PIKE TOWNSHIP FIRE DEPARTMENT

RE: Variance 17-05-13
Day Early Learning
5735 W. 73rd St
Indianapolis, Indiana 46268

Dear Commission Members,
Pike Township Fire Department has reviewed the above variance request that is based on orders to correct violations written on January 23rd, 2017.

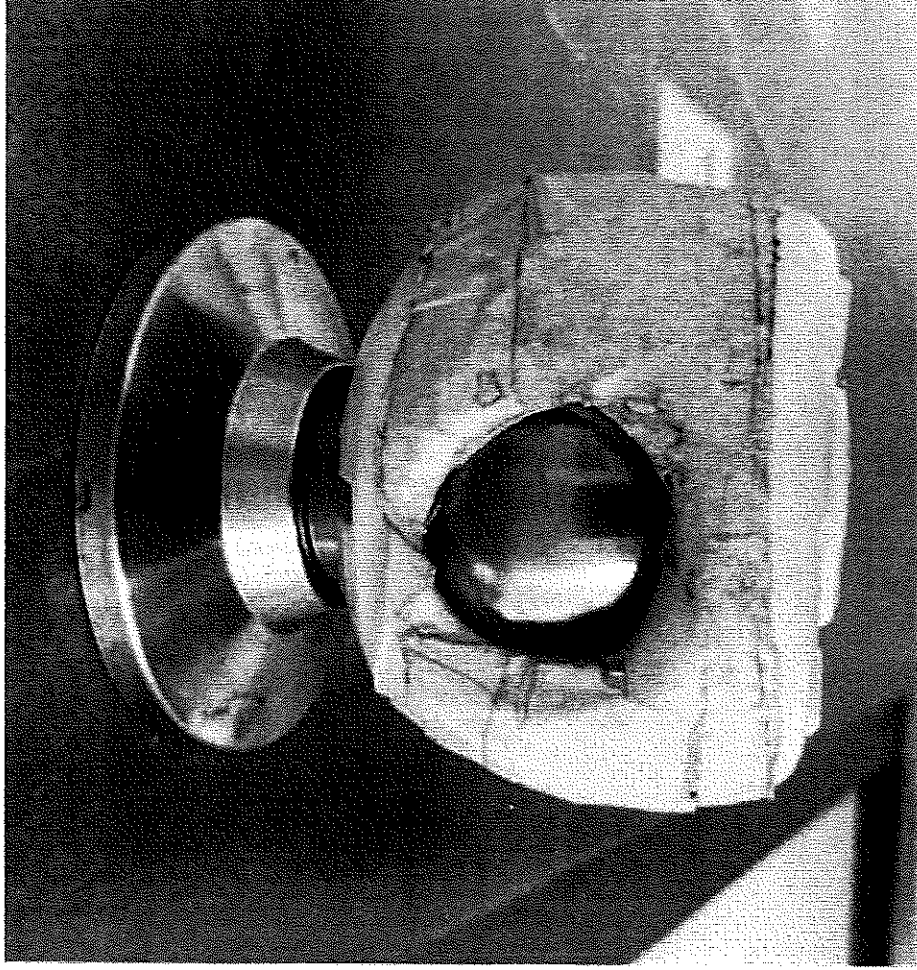
In addition we do not support the request to grant a variance on the requirement of their window blinds not complying with the flame spread and smoke generations requirements of 807.1 of the 2014 Indiana Fire Code. 675 IAC 22-2.5

807.1 General requirements. In occupancies in Groups A, E, I and R-1, and dormitories in Group R-2, curtains, draperies, hangings and other decorative materials suspended from walls or ceilings shall meet the flame propagation performance criteria of NFPA 701 in accordance with Section 807.2 or be noncombustible.

Window blinds are made up of a plastic or vinyl material.

Non Code Compliant
Hardware

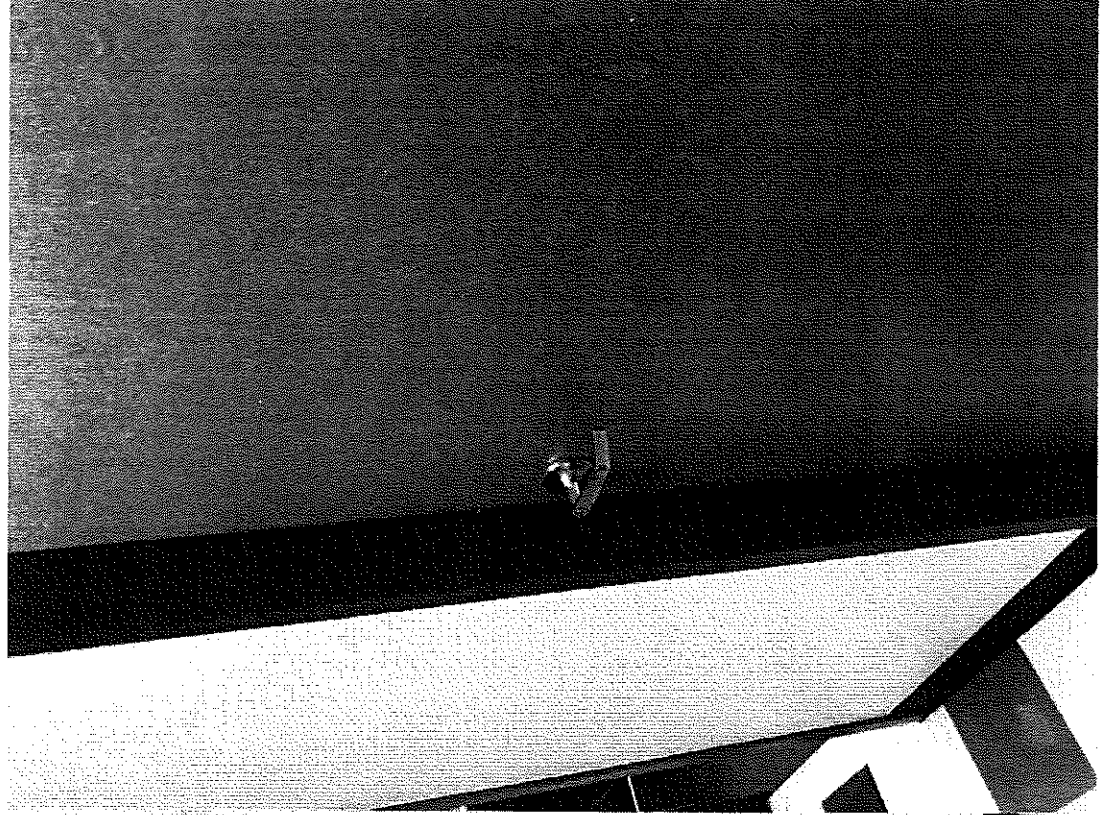
Pike Township Fire Department remonstrates against any variance that would make an exit door difficult to open. The means of egress design is very important to the evacuation of a building. Exit doors hardware is intentionally designed to make doors easy to open and to accommodate people in our community that have disabilities.

[B] 1008.1.9.1 Hardware. Door handles, pulls, latches, locks and other operating devices on doors required to be accessible by Chapter 11 of the *International Building Code* shall not require tight grasping, tight pinching or twisting of the wrist to operate.

[B] 1008.1.9 Door operations. Except as specifically permitted by this section egress doors shall be readily operable from the egress side without the use of a key or special knowledge or effort.

Less than 20% of door knob
surface can be TIGHTLY GRASP to
open exit doors
